Source: T3

Title: CRs to TS 31.102: Characteristics of the USIM Application

Title: ⌘	CR 31.102 Rel-4: Correction of the MMS example	
Source: ⌘	T3	
Work item code: ⌘	TEI	***Date:*** ⌘ 21-05-2003
Category: ⌘	**F**	***Release:*** ⌘ Rel-4

Figure G.1: Structure and Relations of the Example Phone Book

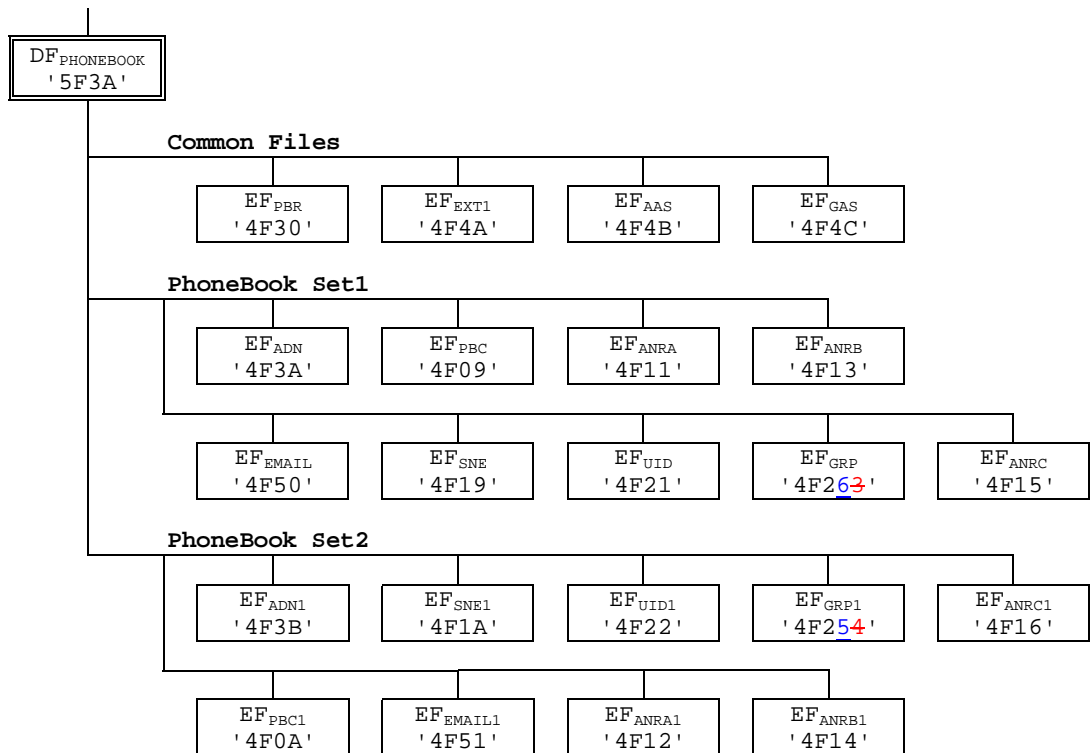
Reason for change: ⌘	The FIDs 4F23 and 4F24 are assigned to the CC and PUID files respectively and shall not be used by another file. DF$_{USIM}$ is incorrect, it must read ADF$_{USIM}$.
Summary of change: ⌘	Change FID of GRP and GRP1 All references to DF$_{USIM}$ are change to ADF$_{USIM}$.
Consequences if not approved: ⌘	Inconsistencies within the specification, leading to confusion and misinterpretation.

Phone book entry	ADN '4F3A' SFI '01'		PBC '4F09' SFI '02'	GRP '4F2~~6~~3'	ANRA '4F11'	ANRB '4F13'	ANRC '4F15'	SNE '4F19'	UID '4F21'	EXT1 '4F4A'	AAS '4F4B'	GAS '4F4C'	EMAIL '4F50'
# 1	ADN Content Bytes (1-(X+13))	EXT1 Ident. (Byte X+14): Rec '02'	Hidden (AID rec N° 3)	Rec n°1 Rec n°3 '00'	ANRA Rec n°1	ANRB Rec n°1	ANRC Rec n°1	Second Name Alpha String	UID	Rec '02'	Record numbers as defined in the ANRs	Record no.'s as defined in GRP	email address
# 2	ADN Content Bytes (1-(X+13))	EXT1 Ident. (Byte X+14): Rec '2A'	Not Hidden	Rec n°2 Rec n°1 Rec n°3	ANRA Rec n°2	ANRB Rec n°2	ANRC Rec n°2	Second Name Alpha String	UID	Rec '2A'	Record numbers as defined in the ANRs	Record no.'s as defined in GRP	email address
# 3													
:													
:													
:													
# 254

| Phone book entry	ADN1 '4F3B'		PBC1 '4F0A'	GRP1 '4F2~~5~~4'	ANRA1 '4F12'	ANRB1 '4F14'	ANRC1 '4F16'	SNE1 '4F1A'	UID1 '4F22'	EXT1 '4F4A'	AAS '4F4B'	GAS '4F4C'	EMAIL1 '4F51'
#255	ADN Content Bytes (1-(X+13))	EXT1 Ident. (Byte X+14): Rec '02'	Hidden (AID Rec n° 3)	Rec n°1 Rec n°3 '00'	ANRA1 Rec n°1	ANRB1 Rec n°1	ANRC1 Rec n°1	Second Name Alpha String	UID	Rec '02'	Record numbers as defined in the ANRs	Record no.'s as defined in GRP1	email address
#256	ADN Content Bytes (1-(X+13))	EXT1 Ident. (Byte X+14): Rec '2A'	Not Hidden	Rec n°2 Rec n°1 Rec n°3	ANRA1 Rec n°2	ANRB1 Rec n°2	ANRC1 Rec n°2	Second Name Alpha String	UID	Rec '2A'	Record numbers as defined in the ANRs	Record no.'s as defined in GRP1	email address
#257													
:													
:													
:													
#508

Figure G.1: Structure and Relations of the Example Phone Book

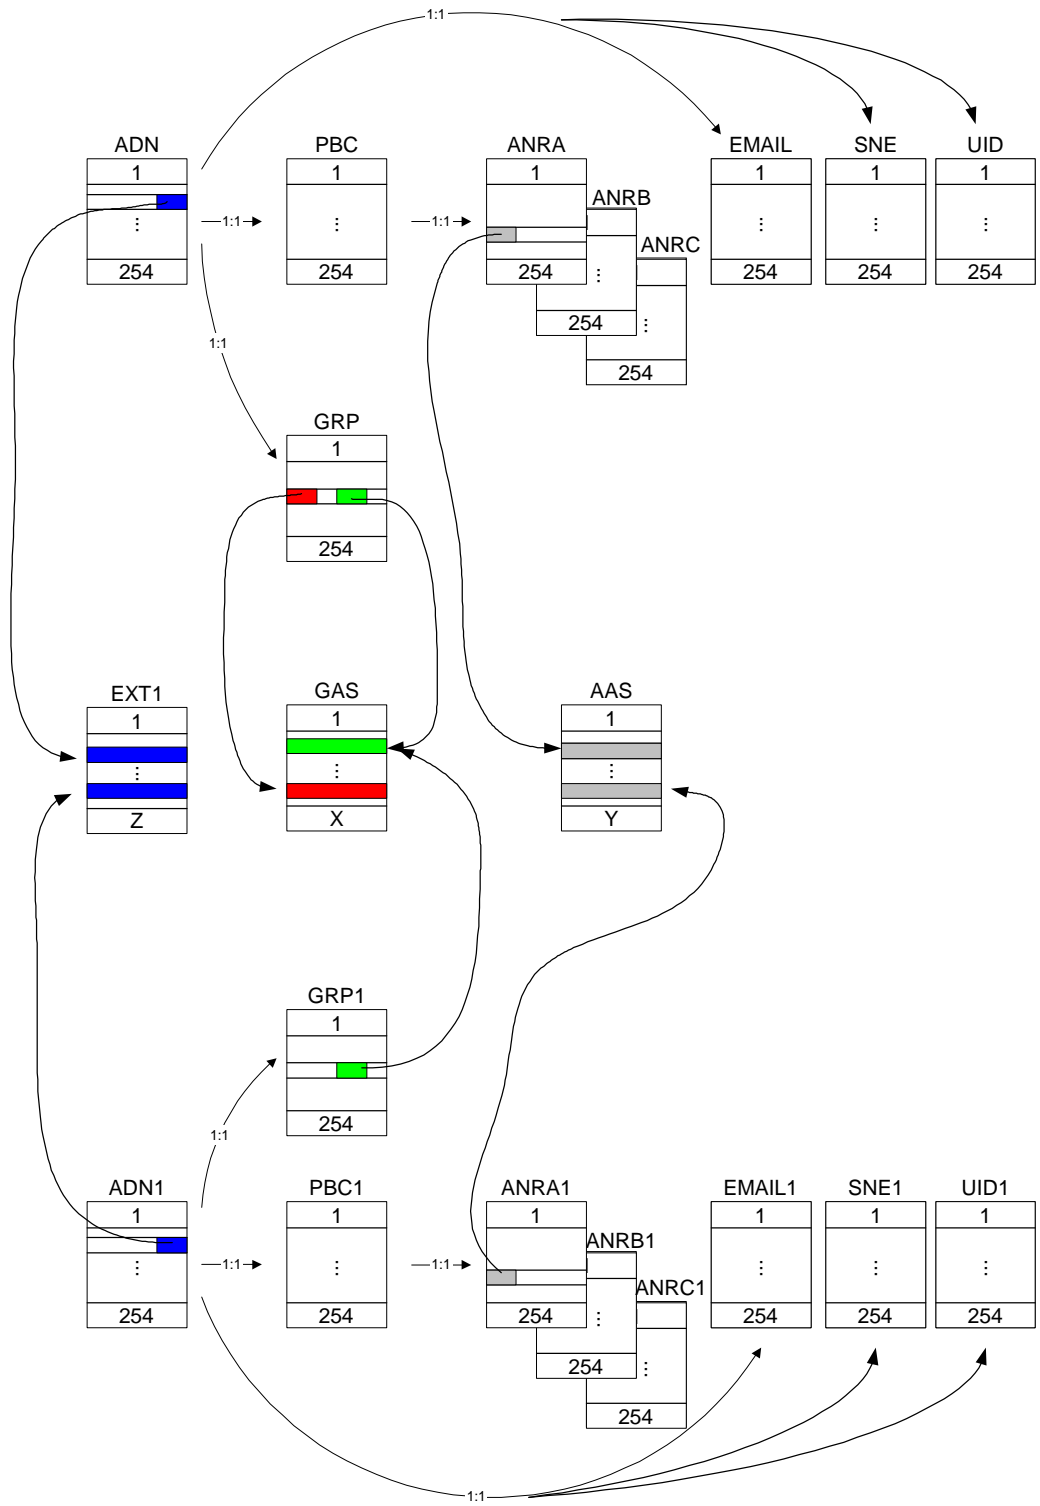
Reason for change: ⌘	The FIDs 4F23 and 4F24 are assigned to the CC and PUID files respectively and shall not be used by another file. DF_{USIM} is incorrect, it must read ADF_{USIM}.
Summary of change: ⌘	Change FID of GRP and GRP1 All references to DF_{USIM} are change to ADF_{USIM}.
Consequences if not approved: ⌘	Inconsistencies within the specification, leading to confusion and misinterpretation.

| Phone book entry	ADN '4F3A' SFI '01'		PBC '4F09' SFI '02'	GRP '4F26~~3~~'	ANRA '4F11'	ANRB '4F13'	ANRC '4F15'	SNE '4F19'	UID '4F21'	EXT1 '4F4A'	AAS '4F4B'	GAS '4F4C'	EMAIL '4F50'
# 1	ADN Content Bytes (1-(X+13))	EXT1 Ident. (Byte X+14): Rec '02'	Hidden (AID rec N° 3)	Rec n°1 Rec n°3 '00'	ANRA Rec n°1	ANRB Rec n°1	ANRC Rec n°1	Second Name Alpha String	UID	Rec '02'	Record numbers as defined in the ANRs	Record no.'s as defined in GRP	email address
# 2	ADN Content Bytes (1-(X+13))	EXT1 Ident. (Byte X+14): Rec '2A'	Not Hidden	Rec n°2 Rec n°1 Rec n°3	ANRA Rec n°2	ANRB Rec n°2	ANRC Rec n°2	Second Name Alpha String	UID	Rec '2A'	Record numbers as defined in the ANRs	Record no.'s as defined in GRP	email address
# 3													
:													
:													
:													
# 254
